- 2. Mansfield 1999 Subdivision Lot 2-A Replat
KPB File 2025-057
Seabright Surveying / Alpe
Location: Mansfield Drive off East End Road
Fritz Creek Area**

**ITEM #2 - PRELIMINARY PLAT
MANSFIELD 1999 SUBDIVISION LOT 2-A REPLAT**

KPB File No.	2025-057
Plat Committee Meeting:	May 27, 2025
Applicant / Owner:	Michael Joseph Alpe and Deborah Ann Alpe of Homer, Alaska
Surveyor:	Katie Kirsis, Seabright Survey + Design
General Location:	Mansfield Avenue, Fritz Creek Area

MANSFIELD 1999 SUBDIVISION LOT 2-A REPLAT

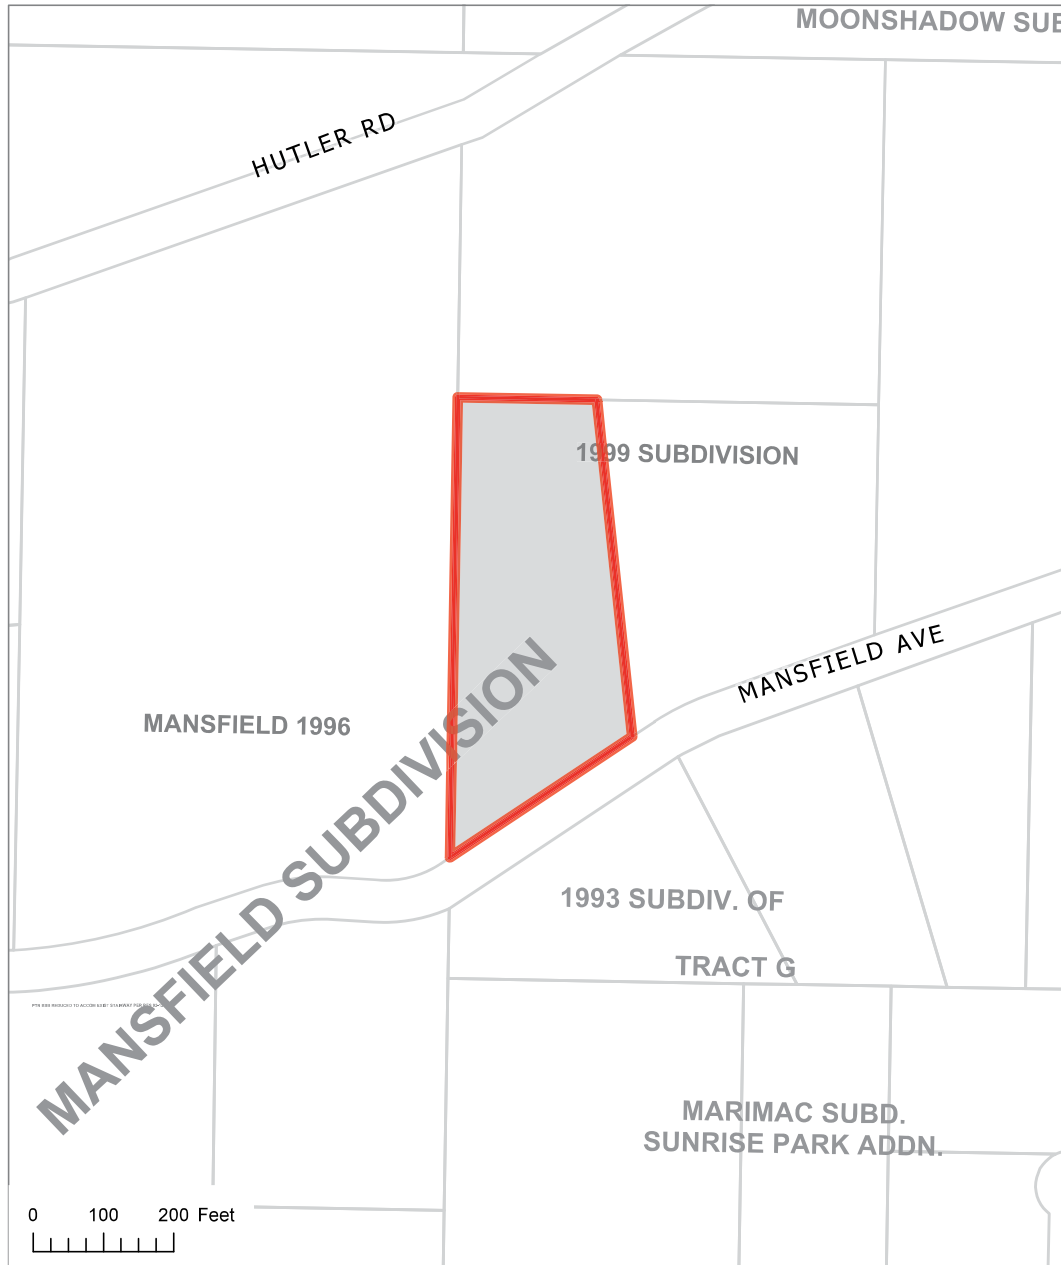
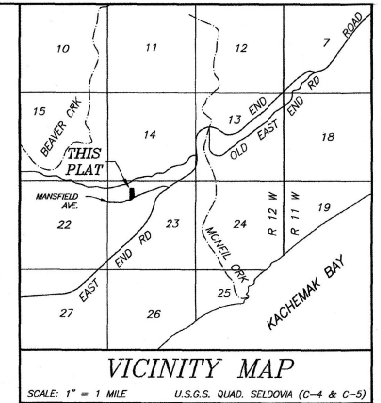
Plat note 1 needs to be corrected to the entire building setback being a utility easement.

Plat note 4 does not affect this plat and can be removed.

Plat Approval certificate needs the date of May 27, 2025 added.

Revise address in the Certificate of Ownership & Dedication to Box 544

- o Modify the KPB File Number to 2025-057
- o Modify the mailing address within the title block to PO Box 544, Walden, CO 80480

- o Provide a label for Hutler Road
- o Add "East" to the East End Road label on the eastern portion of the vicinity map (sections 13 and 7 say "End Road")
- o Add a label for Township 5S

- Modify the north boundary recorded bearing to S89-57-11 (HM 99-68)
- Modify the south boundary recorded distance and bearing to S54-58-06W 311.47 feet (HM 99-68)

- Modify the mailing address for Michale Joseph Alpe to PO Box 544, Walden, CO 80480
- Include the meeting date of May 27, 2025 to the Plat Approval

MANSFIELD 1999 SUBDIVISION LOT 2-A REPLAT

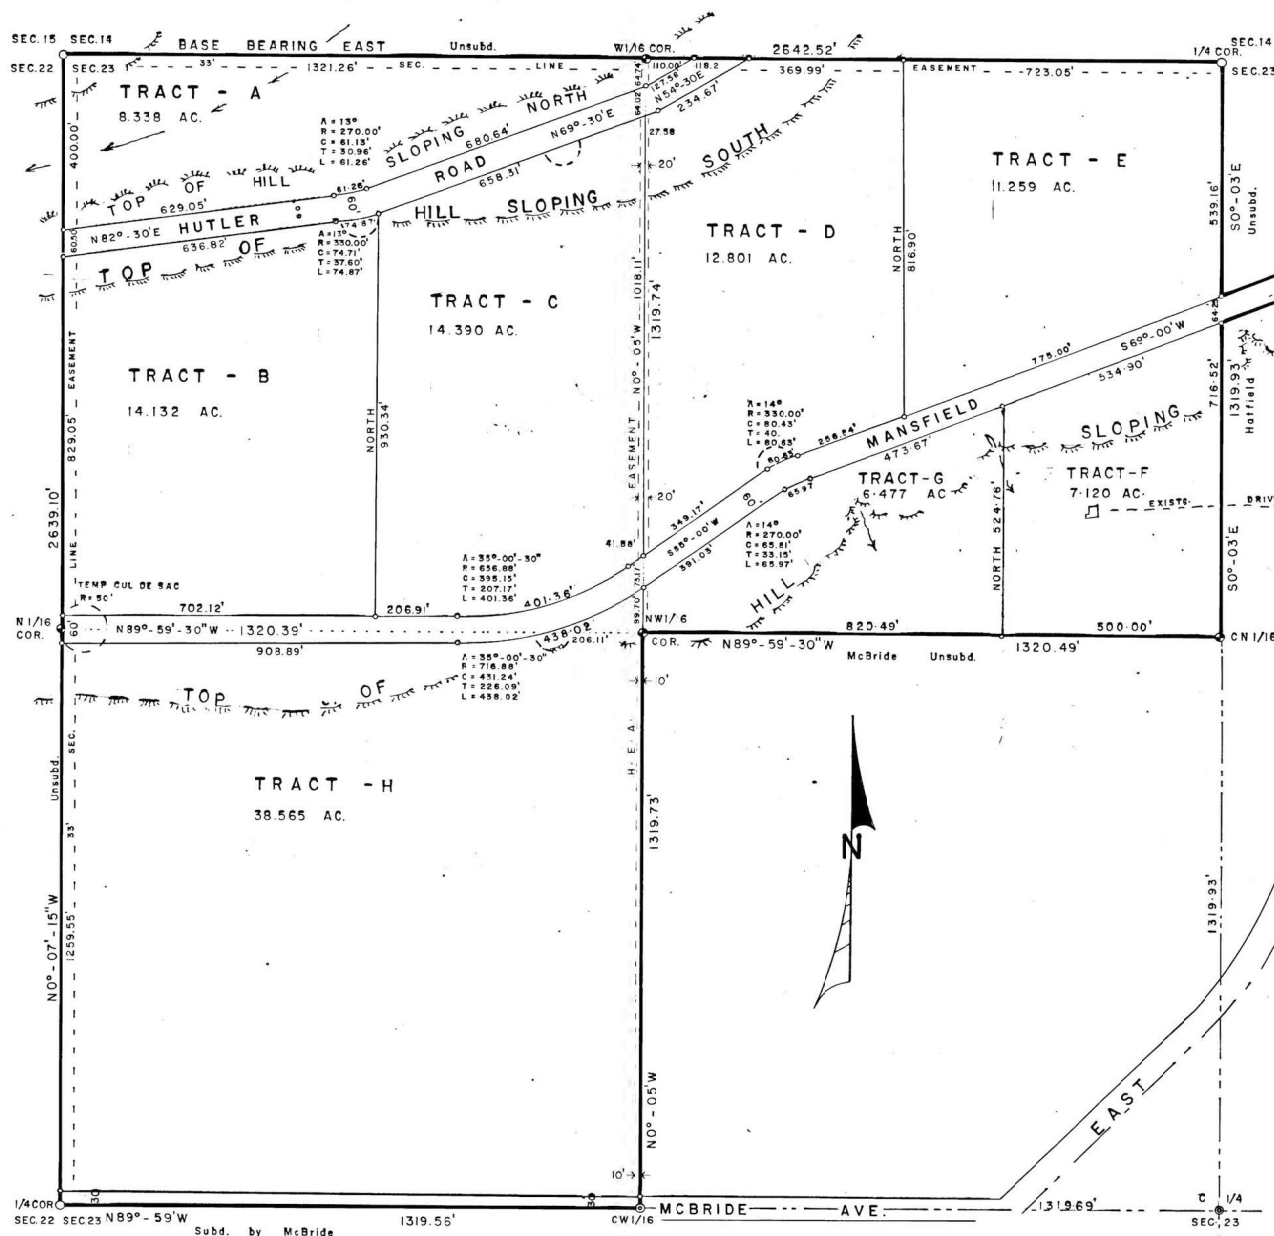
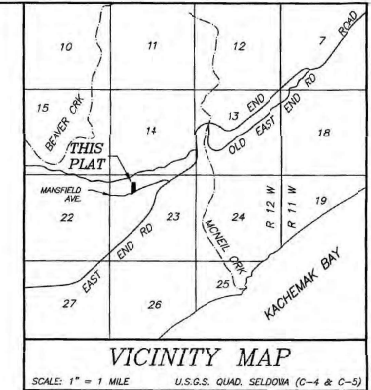
This is a 15 foot easement adjoining the east boundary of former Lot 2 and does not affect this platting action. Plat note 4 can be removed for the final plat.
